STAFF RECOMMENDATION

1510 Holly Street

August 19, 2020

Application: New Construction—Infill and Outbuilding/Detached Accessory Dwelling Unit

Figure 5 (left) is the area to be removed. Figure 6 (center) is the 1914 Sanborn map where this part of the house does not appear and Figure 7 (right) is the 1951 Sanborn map where it appears as a porch.

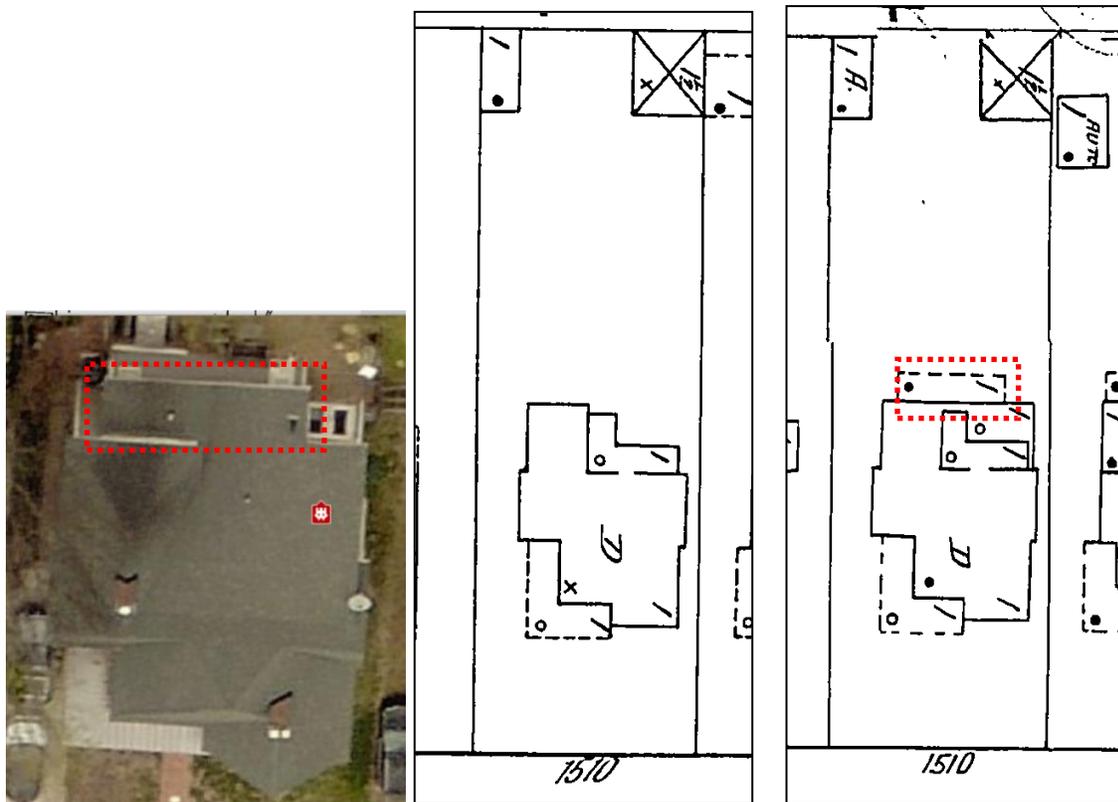
Demolition: The rear addition requires the removal of an existing appendage at the rear (Figure 5). The date of construction of this part of the house is not known; it appears in the 1951 Sanborn map as a porch but not on the 1914 Sanborn Map (Figures 6 & 7). Staff finds that this part of the house is not historically or architecturally significant, as it is not original, and that its removal meets the design guidelines.

Staff finds that the proposed partial demolition meets Section III.B.2 for appropriate demolition and does not meet Section III.B.1 for inappropriate demolition.

Figure 5. The alley façade of the garage that MHZC approved in 2005, but which was demolished by the March 2020 tornado.

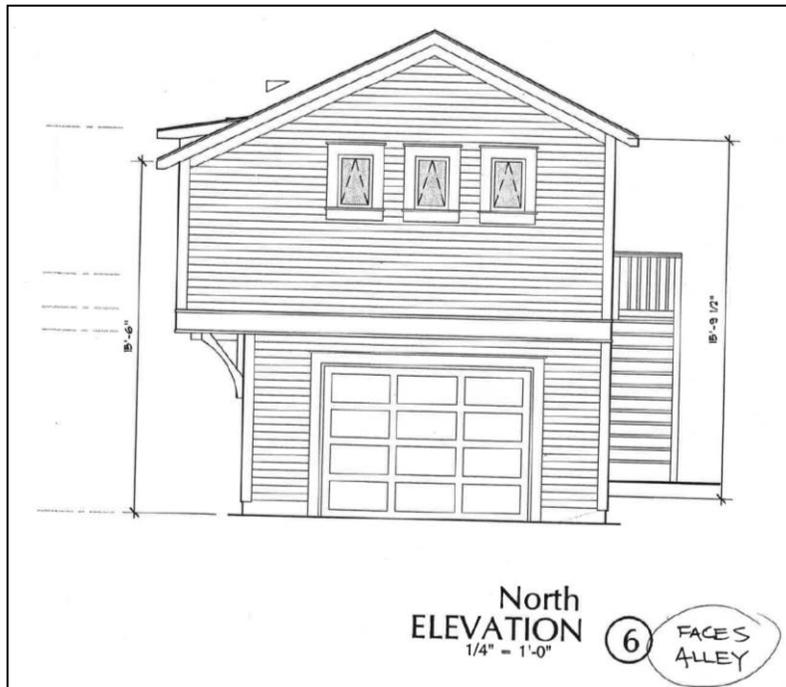
Outbuildings: Staff is proposing a two-story outbuilding. Typically, MHZC staff would limit any outbuilding here to a one or one-and-one-half story structure. However, the outbuilding that was destroyed in the 2020 tornado was two stories and had been approved by MHZC in 2005 (Figure 5).

The project meets section II.B.8 of the design guidelines and ordinance 17.16.030.G for detached accessory dwelling units.
